PROJECT NAME:
536 Harvard

The proposal to the HAHC was to have 7' 9-Lite fixed windows. Rather than do a change out on these we can create a 9-Lite window grid and place over the obscured glass. (can be easily removed) Luke I will defer to you whether we need to do anything here for the re-submittal.

CERTIFICATE OF APPROPRIATENESS APPLICATION FORM

Address 536 HARVARD
Historic District / Landmark
Subdivision HOUSTON HEIGHTS HCAD# 0210214000021
Lot 21 Block 289

HARVARD FRONT ELEVATION

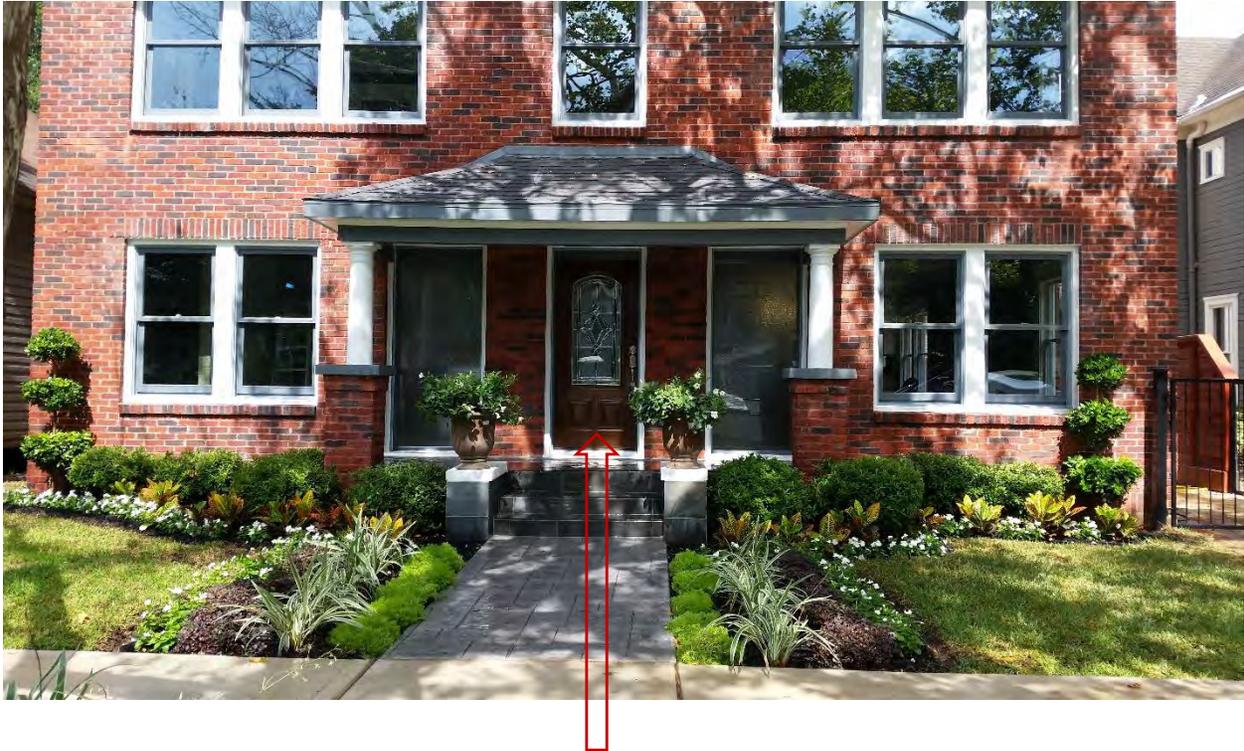
The recommendation from the HAHC was to leave the front door. Upon inspection there was significant water damage to the door base, broken grids on the interior, and a significant warp not allowing the door to close properly. We replaced with a single lite lead glass mahogany door. Please change and re-submit.

HARVARD PORCH COLUMN

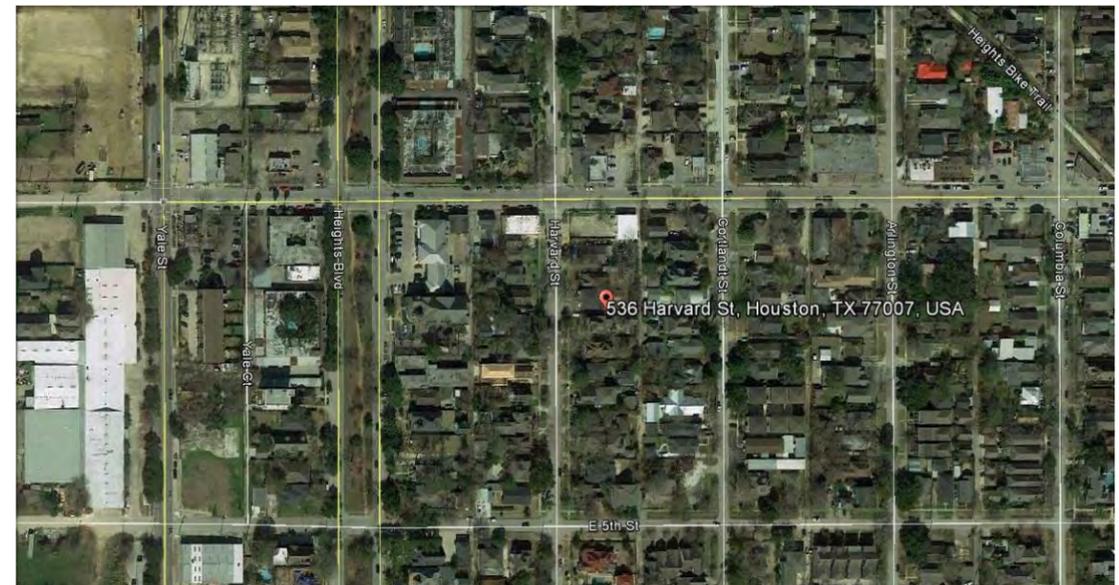
The original round support columns were left intact instead of changing to square as was originally suggested. The HAHC recommendation was to leave the existing columns, which we did.

Brick cladding with cap was added in keeping with the period architecture in the Heights. This was not in the original request. Please make the changes and re-submit for approval.
